Subject: Tag Axle Lock Clamps Rework			
Field Change Program: Field Campaign	FCP Number: 477	Revision: A	Date: MM/DD/YYYY
Coach Section: 12- Suspension	P/N: 12-04-1253		Type: Safety Recall

Ref. NHTSA Recall No.: 19V-924	Ref. Transport Canada Recall No.: N/A
--	---

1.0 Description

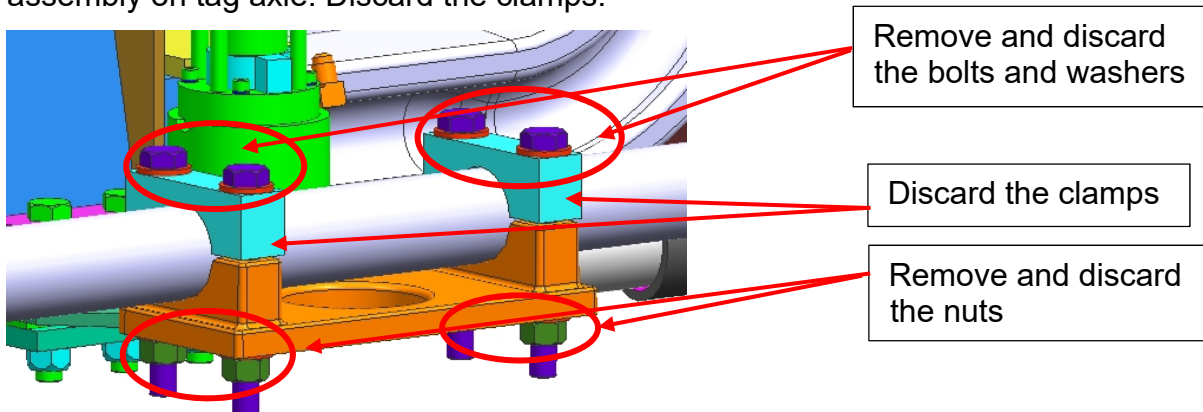
Scribe the location of the clamp and lock plate on the tie rod.

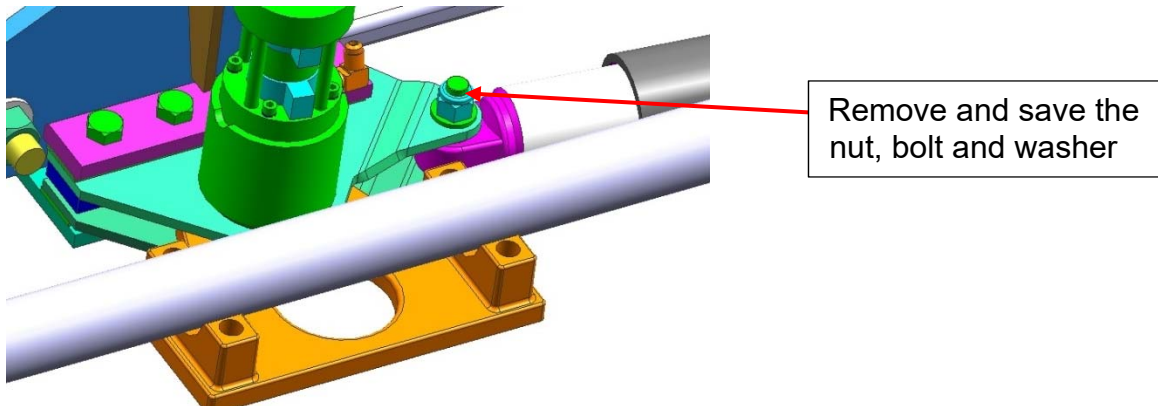
Remove and discard the 4 nuts, bolts and washers securing the clamp to the lock assembly on tag axle. Discard the clamps.

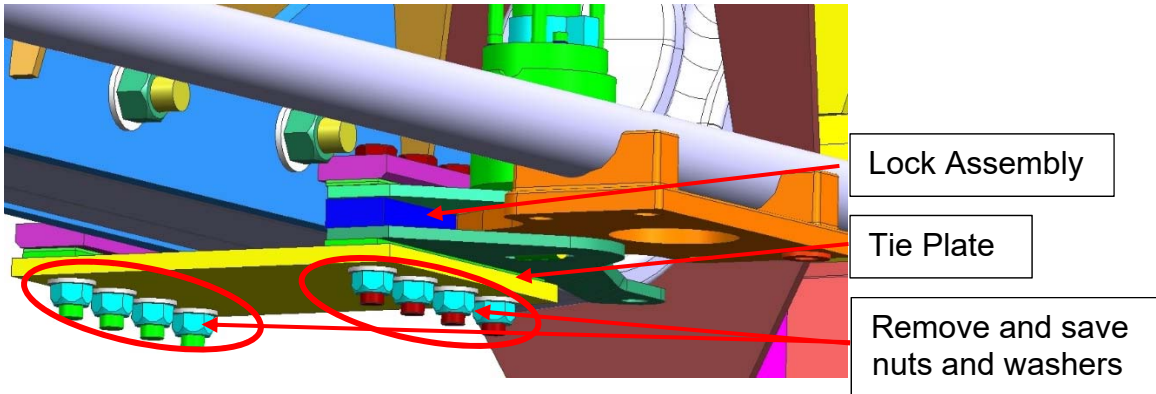
Remove and save the nut, bolt, and washer securing the lock assembly and the damper.

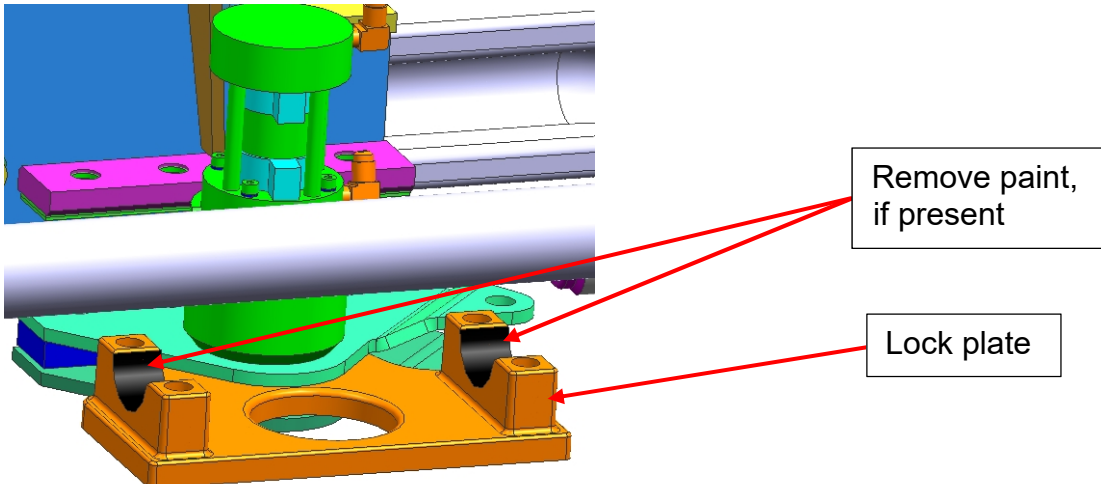
Remove and save the 8 nuts and washers securing the tie plate to the lock assembly and to the axle. Save the tie plate and shims.

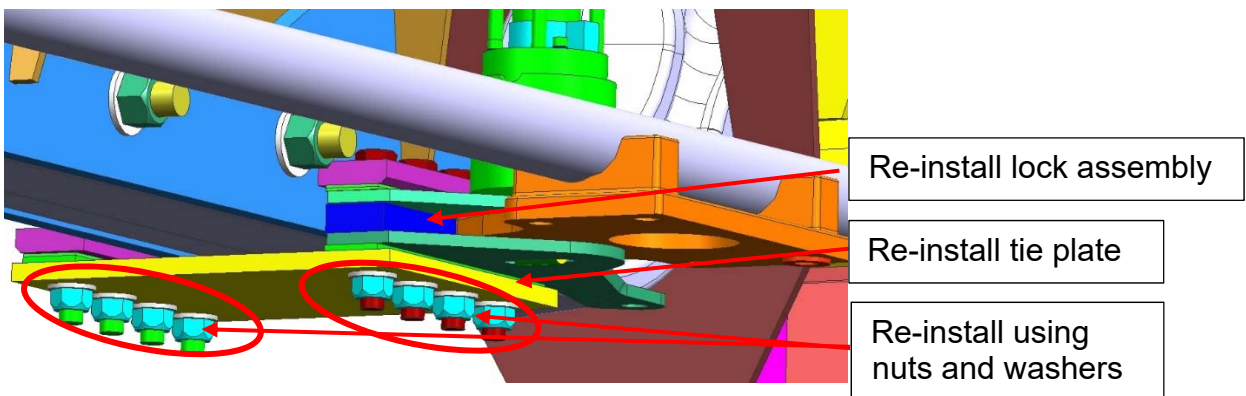
Slide the lock assembly and lock plate down and observe for paint on the lock plate at the location illustrated below. If paint is observed on the surface of the lock plate that clamps the tie rod, use an abrasive paper to remove the paint in that area.

Clean the lock assembly plate with isopropyl alcohol, MCI P/N: 23-05-0005.

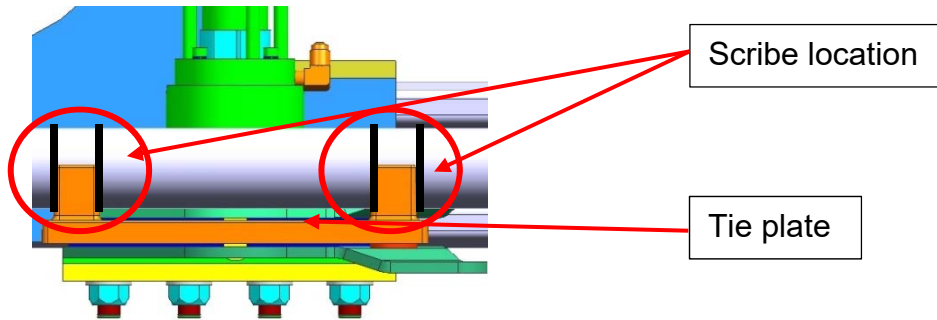
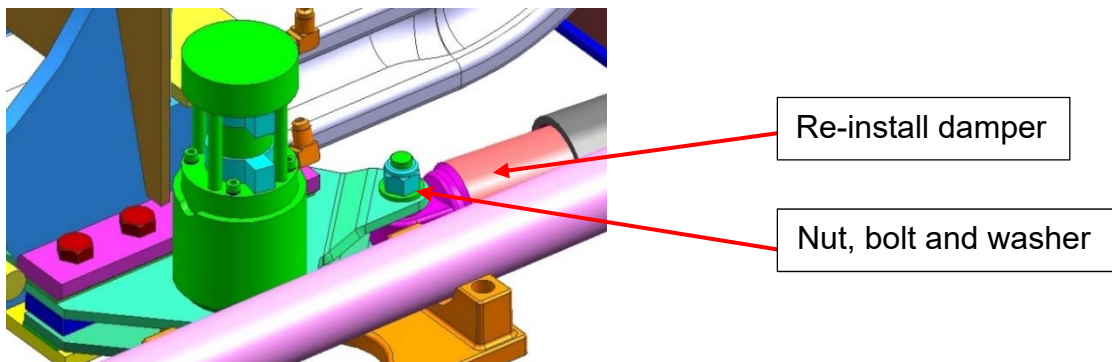
Re-install tie plate, lock plate, and lock assembly to the axle at the scribed location using existing nuts, bolts, washers and shims. Torque the nuts to 87 Ft-Lb.

Make sure to position the lock plate at the scribed location.

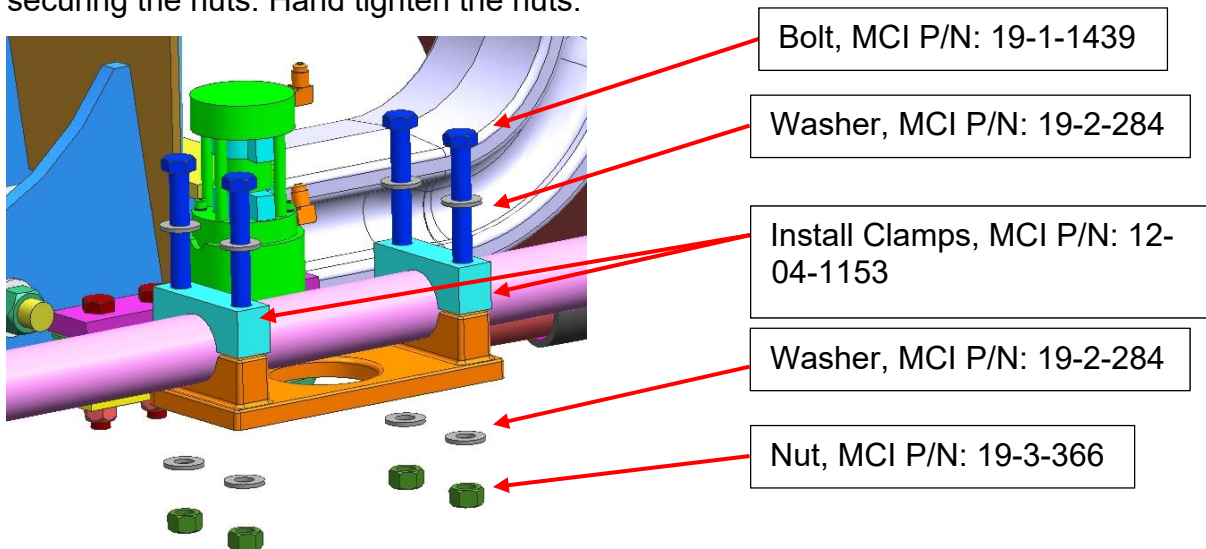
Re-install the damper to the lock assembly using existing hardware. Torque the nut to 87 Ft-Lb.

Clean the clamps, MCI P/N: 12-04-1153, with isopropyl alcohol, MCI P/N: 23-05-0005.

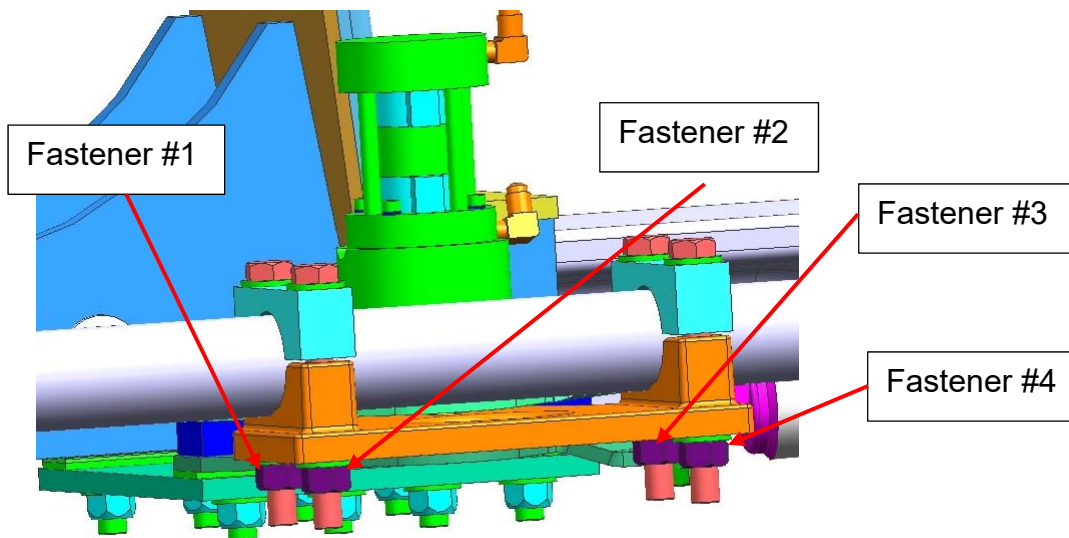
Install the clamps to lock assembly using nuts, MCI P/N: 19-3-366, washers, MCI P/N: 19-2-284, and bolts, 19-1-1439. Apply Loctite to the base threads of the bolts before securing the nuts. Hand tighten the nuts.

Torque the nuts as follows:

Torque fastener #1 to 15 Ft-Lb

Torque fastener #4 to 15 Ft-Lb

Torque fastener #2 to 15 Ft-Lb

Torque fastener #3 to 15 Ft-Lb

Repeat torquing the fasteners in the same sequence incrementing torque by 15 Ft-Lb until you reach 75 Ft-Lb.

Apply thread seal once all the fasteners are torqued to 75 Ft-Lb.
